UNITED STATES DEPARTMENT OF COMMERCE United States Patent and Trademark Office Address: COMMISSIONER FOR PATENTS P.O. Box 1450 Alexandria, Virginia 22313-1450 www.uspto.gov

APPLICATION NO.	FILING DATE	FIRST NAMED INVENTOR	ATTORNEY DOCKET NO.	CONFIRMATION NO.
10/547,204	08/26/2005	Uwe Zoller	SMB-PT155 (PC 04 019 B 7991 US	
VOLPE AND KOENIG, P.C. UNITED PLAZA, SUITE 1600			EXAMINER	
			BOECKMANN, JASON J	
30 SOUTH 17TH STREET PHILADELPHIA, PA 19103		•	ART UNIT	PAPER NUMBER
	·		3752	
•				
			MAIL DATE	DELIVERY MODE
			07/20/2007	PAPER

1	Application No.	Applicant(s)				
	10/547,204	ZOLLER, UWE				
Office Action Summary	Examiner	Art Unit				
	Jason J. Boeckmann	3752				
The MAILING DATE of this communication appears on the cover sheet with the correspondence address Period for Reply						
A SHORTENED STATUTORY PERIOD FOR REPLY IS SET TO EXPIRE 3 MONTH(S) OR THIRTY (30) DAYS, WHICHEVER IS LONGER, FROM THE MAILING DATE OF THIS COMMUNICATION. - Extensions of time may be available under the provisions of 37 CFR 1.136(a). In no event, however, may a reply be timely filed after SIX (6) MONTHS from the mailing date of this communication. - If NO period for reply is specified above, the maxi

Examiners marked up figure 6

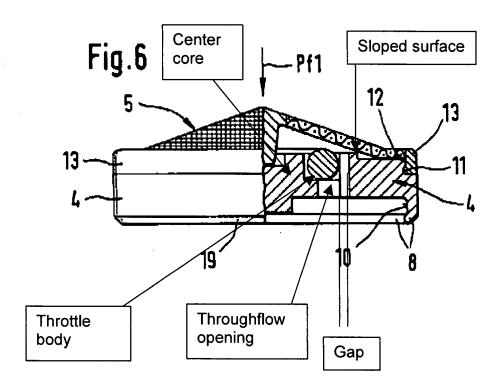
Muchenberger et al shows a unit for insertion into a discharge fitting comprising: a substantially cone-shaped upstream sieve (5) with a throughflow regulator (4) and a

jet regulator (3) positioned downstream in a flow direction, wherein the throughflow regulator is arranged generally inside an interior space (fig 1) of the insert defined by the upstream sieve. The throughflow regulator is provided with a cross-sectional profile that is substantially complementarily form fitting a cross-sectional profile of the upstream sieve (fig 1).

Regarding claims 3 and 7, the throughflow regulator has an exterior edge with a radially inward rising sloping surface (the top of the throughflow regulator where the surface steps up to substantially conform to the cross-section of the sieve (5) has a 90 degree inwardly rising sloped surface) which leads to a throughflow opening connected to a control gap (see examiners marked up figure 6 below). The control gap is also provided with a central core area which is surrounded by a throttle body and the rising sloped surface having a throughflow cross-section being adjustable by the throttle body.

Regarding the applicant's arguments towards the 102 rejections, the claim language states that the throughflow regulator is "arraigned generally inside an interior space of the insert defined by the upstream sieve." It is respectfully noted that the throughflow regulator (4) of Muchenberger's invention is located generally inside a space, by which the top is defined by the upstream sieve (5), the space being in the insert. The word generally is taken to mean that not all of the throughflow regulator has to be inside the said space, but that most of it has to lie inside the said space.
